Denial of a Certificate of Appropriateness – 425 N 10th Street

CITY OF ALLENTOWN HISTORIC ARCHITECTURAL REVIEW BOARD FINAL REVIEW SHEET January 10, 2018

Case #HDC-2018-00040— Proposal to continue installation of the satellite dish installed on the front of the building.

Property located at: 425 N 10th Street

Street View - Sep 2017

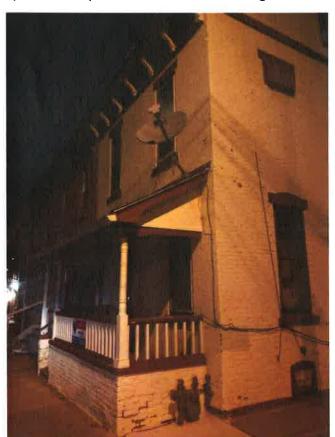
Violations: May 8, 2012 – Installed two satellite dishes on front porch roof. Dishes removed.

December 5, 2018 – Satellite dish installed on front of building.

-Mounting mechanical, electrical, and communications equipment and devices on a primary façade is not appropriate.

-Equipment such as a satellite dishes should not be mounted on sloped roofs visible from the public Right-of-Way on which the building fronts.

Evaluation, **effect on historic district**, **recommendations**: The dish should be removed and relocated to a less visible side (rear).

Discussion: The applicant did not attend the HARB meeting. The HARB debated whether to table the case or to deny it. Mr. Kimmerly said the applicant/owner had not indicated willingness to move the satellite dish when he spoke with him, but he was willing to try again to get compliance if the HARB tabled the case. The HARB concluded, however, that this was a clear

- 1. Discussion of this project was difficult without the attendance of the applicant.
- 2. The installation is a clear violation of the historic design guidelines and must be removed from the front façade.
- 3. The satellite dish should be relocated to one of the rear flat roof areas of the building not visible from the street.
